# **NORTHWEST ASSOCIATED CONSULTANTS, INC.**

## **MEMORANDUM**

TO: Phil Kern  
FROM: Alan Brixius  
DATE: May 8, 2024  
RE: Delano - Parkview Hills North - 2024 Preliminary Plat / Final  
FILE NO: 432.07 - 24.04

#### EXHIBIT C

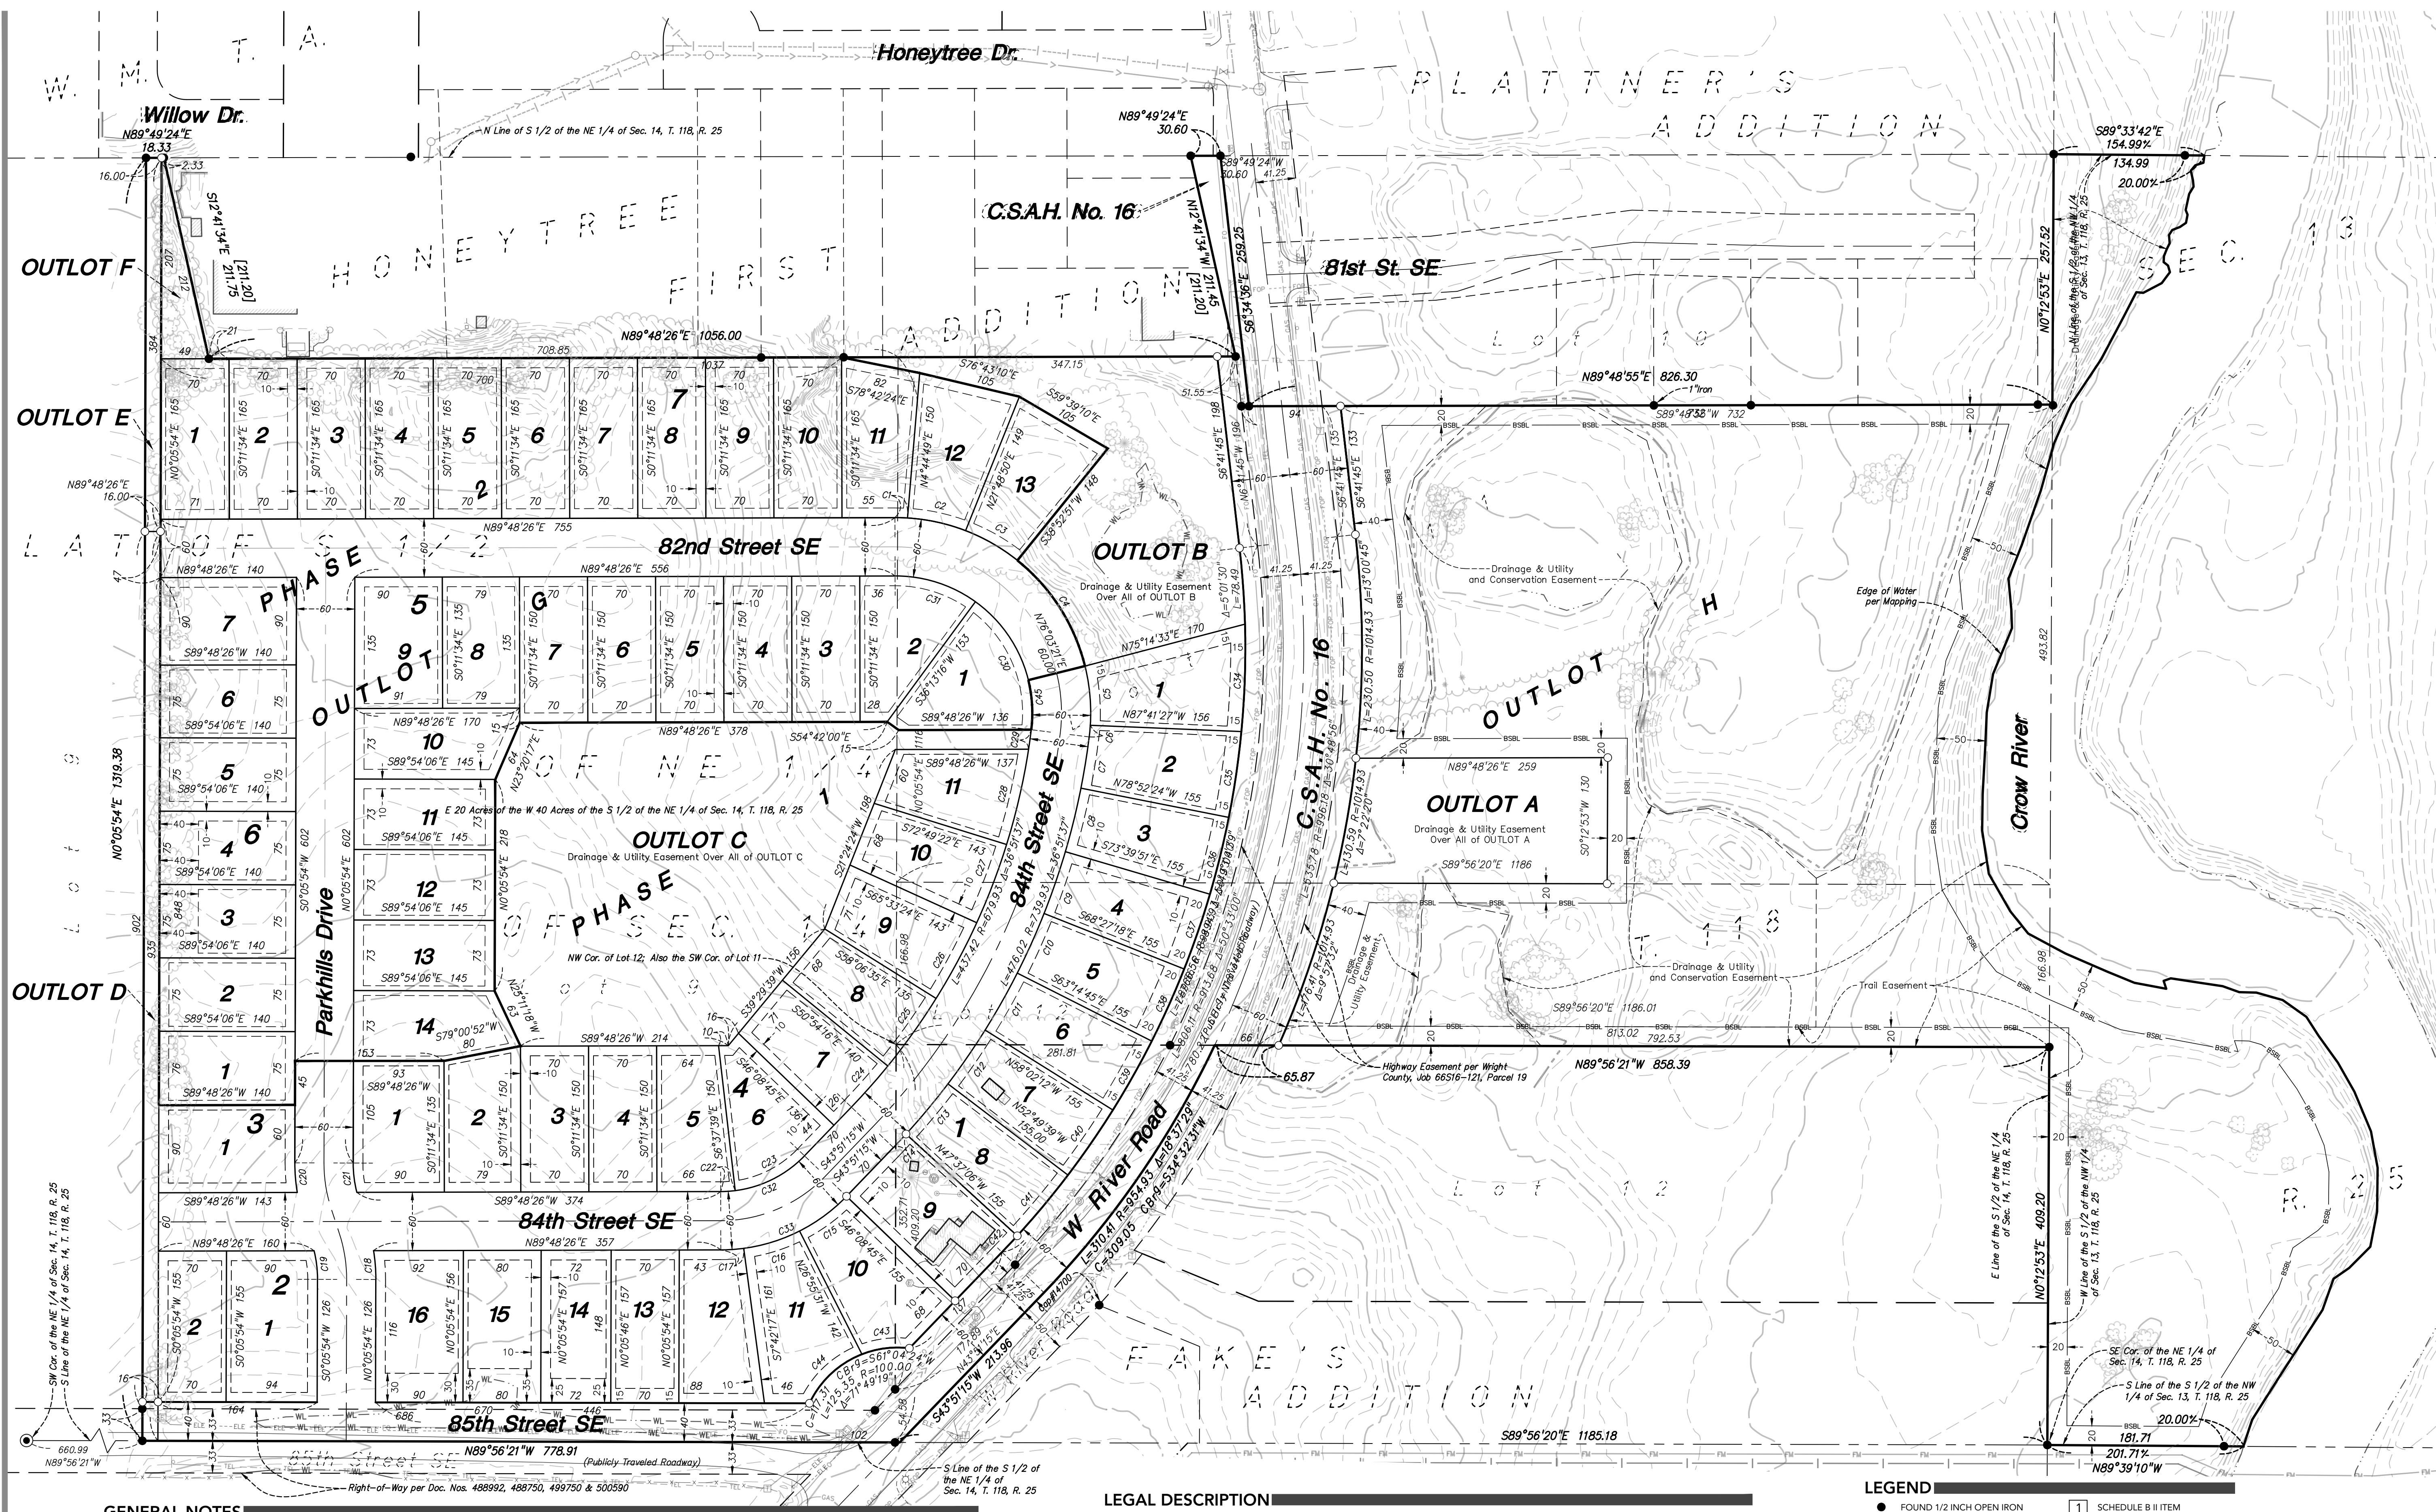
1. The alignment of Parkhills Drive and 84<sup>th</sup> Street SE is not an aligned intersection. The plat must be redesigned to provide an aligned full intersection. Street plans shall be subject to the review and approval of the City Engineer.
2. The streets shall be named in accordance with the City's Street naming policy.
3. Streetlights and traffic control signs shall meet City design standards and related installation costs shall be borne by the subdivision.
4. The final plat shows the extension of 84<sup>th</sup> Street north for 1040 feet. The plat and development plans must illustrate the provision of a temporary cul-de-sac.

Block 4, Lot 6. This is a triangular lot, with a narrow rear yard. The rear lot line shall be straightened between Lots 5 and 7. Property demarcation posts shall be required at the rear lot corners to designate lot boundary between the lots and outlot C.

Block 5, Lots 1 and 2. These are triangular lots, with narrow rear yards. Property demarcation posts shall be required at the lot corners to designate lot boundary between the rear lots and outlot C and clearly define the boundaries of these lots.

Block 5, Lot 14. Straighten south lot line of Lot 14 through Lot 2, to avoid future lot line disputes.

**Easements.** Easements are shown of the submitted preliminary plat drawing consistent with the submittal requirements of the City's Subdivision Ordinance, the submitted preliminary plat drawing must be revised to illustrate all easements.

3. The alignment of Parkhills Drive and 84<sup>th</sup> Street SE is not an aligned intersection. The plat must be redesigned to provide an aligned full intersection. Street plans shall be subject to the review and approval of the City Engineer.

8. Individual lots shall be prohibited from receiving direct access from County Road 16 and 85<sup>th</sup> Street.
9. Block 4, Lot 6. This is a triangular lot, with a narrow rear yard. The rear lot line shall be straightened between Lots 5 and 7. Property demarcation posts shall be required at the rear lot corners to designate lot boundary between the lots and outlot C.

10. Block 5, Lots 1 and 2. These are triangular lots, with narrow rear yards. Property demarcation posts shall be required at the lot corners to designate lot boundary between the rear lots and outlot C and clearly define the boundaries of these lots.

11. Block 5, Lot 14. Straighten south lot line of Lot 14 through Lot 2, to avoid future lot line disputes.
12. Outlots A, B, C and F shall be dedicated to the City in fee title.

13. The submitted preliminary and final plats shall be revised to illustrate all easements. Easements shall be placed over rear yard drainage swales. All easements shall be subject to review and approval of the City Engineer. No construction of sheds, fences, patios or filling may occur with the drainage and utility easements.
